**MONTGOMERY COUNTY HISTORIC PRESERVATION COMMISSION**  
**STAFF REPORT**

<b>Address:</b>	10201 Menlo Ave.	<b>Meeting Date:</b>	4/24/2019
<b>Resource:</b>	Vacant lot Capitol View Park Historic District	<b>Report Date:</b>	4/17/2019
<b>Applicant:</b>	Minter Farnsworth	<b>Public Notice:</b>	4/10/2019
<b>Review:</b>	HAWP	<b>Tax Credit:</b>	n/a
<b>Case Number:</b>	31/07-19B	<b>Staff:</b>	Dan Bruechert

**Proposal:** New Construction of a Single Family Dwelling, tree removal, construction of a fence and retaining wall

Figure 2: The subject lot with the identified easements and other limitations. Zoning restrictions are shown in orange, the conservation easement is in olive, the sewer easement is in red, the water easement in blue, and the storm drain in yellow.

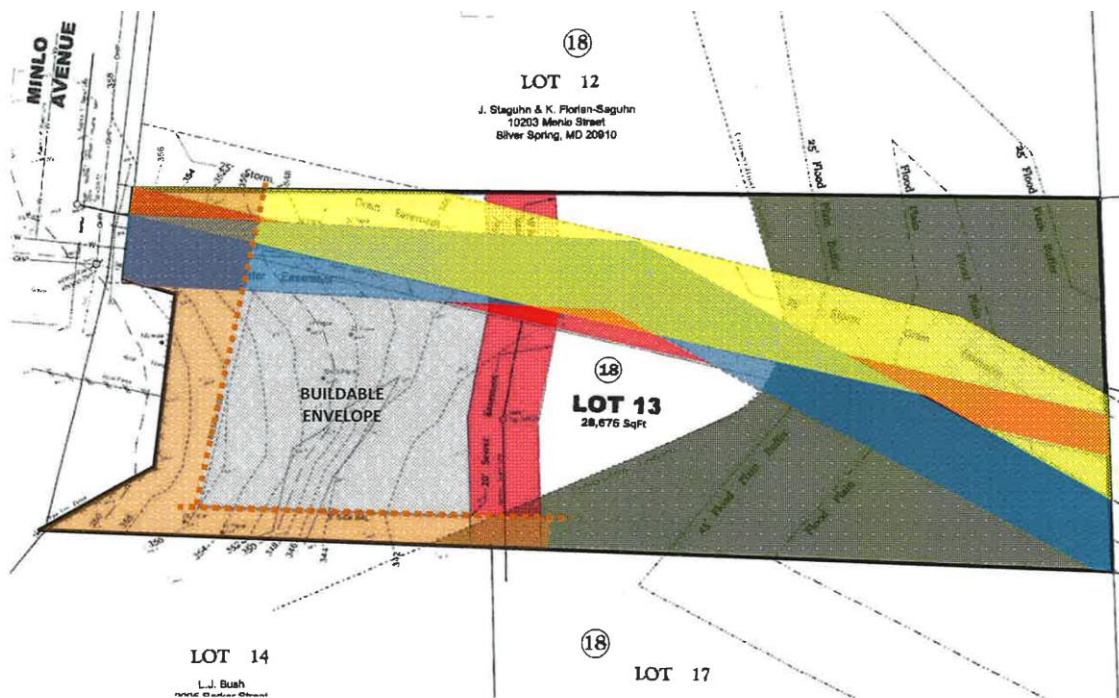
In order to accommodate the proposed construction, the application proposes to remove a total of nine trees on the site. Four of these trees are located at the entrance to the lot and have to be removed to provide access to the site. Staff finds that to deny the applicant the ability to remove these trees would deny any reasonable use of the subject property, contravening 24A-8(b)(5). Another three trees are at the center of the buildable envelope and any house construction on the site would require the removal of these trees. Two more trees proposed for removal are located near the southern property boundary within the limits of disturbance. Staff finds that the proposed tree removal will impact the character of the site. However, Staff finds there are several mitigating measures to be considered. First, under the forest conservation program, the applicant is required to re-plant trees one-for-one or pay a fee in lieu. Staff recommends that a maximum number of trees be re-planted on the site and that the species and placement be included with the submission of permit drawings for stamping. Second, the conservation

easement that encompasses the rear third of the lot may not be impacted by any of the work on the site or construction and will maintain its wooded character. Staff supports the removal of these trees as part of the work proposed under this HAWP.

1. Staff recommends that a maximum number of trees be re-planted on the site and that the species and placement be included with the HAWP application

Figure 3: Setback study demonstrating the range of setbacks along Menlo Ave.

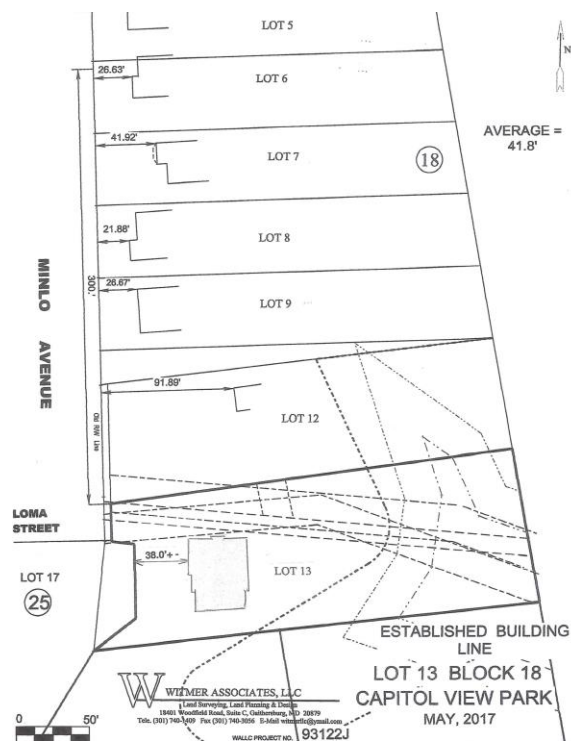
The applicant included a setback study (shown below) with the application materials. The setbacks on this section of the historic district range from approximately 22' from the street (twenty-two feet) to nearly 92' (ninety-two feet). While the setback of the proposed construction is slightly deeper than many of the late 18<sup>th</sup> century and 1920s houses further up the block, Staff finds it is within the range of adjacent setbacks at 38' (thirty-eight feet) and should be determined to be compatible with the surrounding district. Staff finds that the setbacks alone should not be used as a sole factor to determine compatibility because this particular lot has so many additional encumbrances (easements, zoning requirements, utility lines) that severely limit many further alterations to the setbacks.

Staff also finds that the placement of the house on this unique lot configuration makes for less impact than new construction on a lot mid-block.

Figure 4: Streetscape study along Menlo Ave.

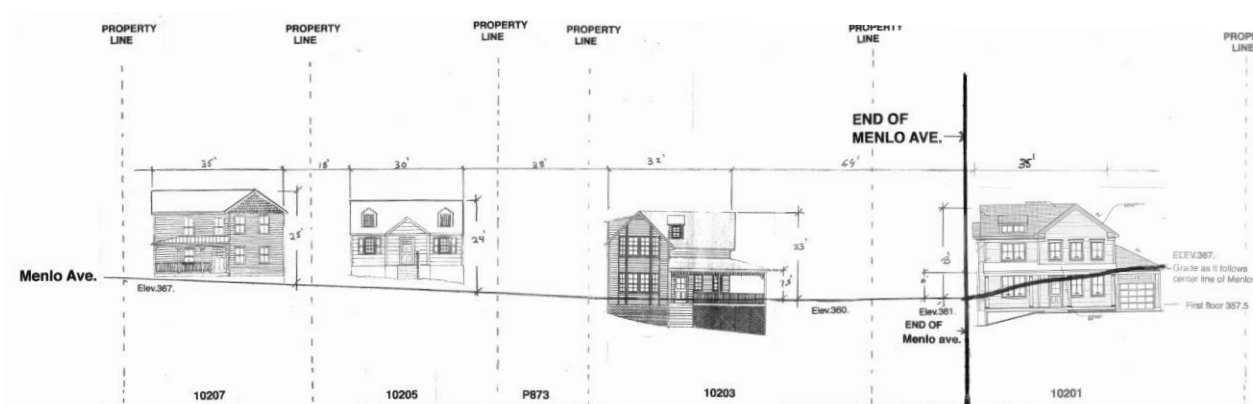
The proposed construction will be 23' (twenty-three feet) above the grade of Menlo Ave. Staff finds that the height is generally consistent with the surrounding district (see the streetscape study below).

Staff finds the height of the proposed building above street grade is identical to its immediate neighbor to the north (10203 Menlo Ave.) and lower than both 10205 and 10207 Menlo Ave.
